U.S. Department of the Interior BUREAU OF LAND MANAGEMENT **Sundry Print Report**

Sundry ID: 2737328

# EPIC Energy – Federal I-22 #2

# **CONDITIONS OF APPROVAL**

#### Proposed P&A

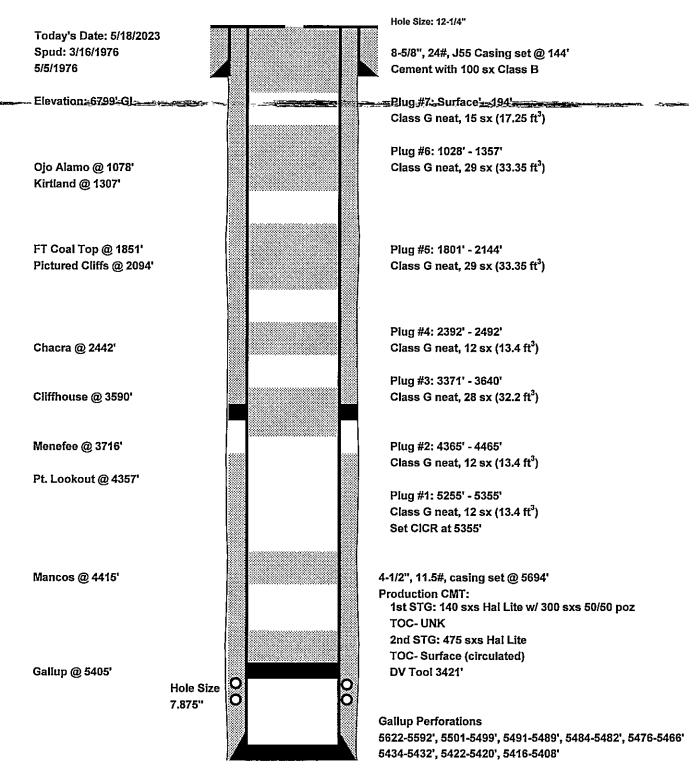
- 1. Plugging operations authorized are subject to the attached "General Requirements for Permanent Abandonment of Wells on Federal and Indian Lease."
- 2. The following modifications to your plugging program are to be made:
  - a. Adjust Plug #2 (Mancos) to cover BLM formation top @ 4630'.
  - b. Adjust Plug #5 (Pictured Cliffs/ Fruitland) to cover BLM Fruitland top @ 1756'.
  - c. Adjust Plug #6 (Kirtland/ Ojo Alamo), or add a plug, to cover BLM Kirtland top @ 1602' and Ojo Alamo top @ 1430'.
- 3. Farmington Office is to be notified at least 24 hours before the plugging operations commence at (505) 564-7750.

Remarks:	Reference Well:
- Gallup perfs 5408' - 5622'.	1) Formation Tops
	Epic Energy, LLC
- Adjust Plug #2 (Mancos) to cover BLM formation top @ 4630'.	Ernest #001
	3003905338
- Adjust Plug #5 (Pictured Cliffs/Fruitland) to cover BLM Fruitland top @ 1756'.	Sec. 27, T24N, R07W
	Elev. (GL) 6798'
- Adjust Plug #6 (Kirtland/Ojo Alamo), or add a plug, to cover BLM Kirtland top @ 1602' and Ojo Alamo top @ 1430'.
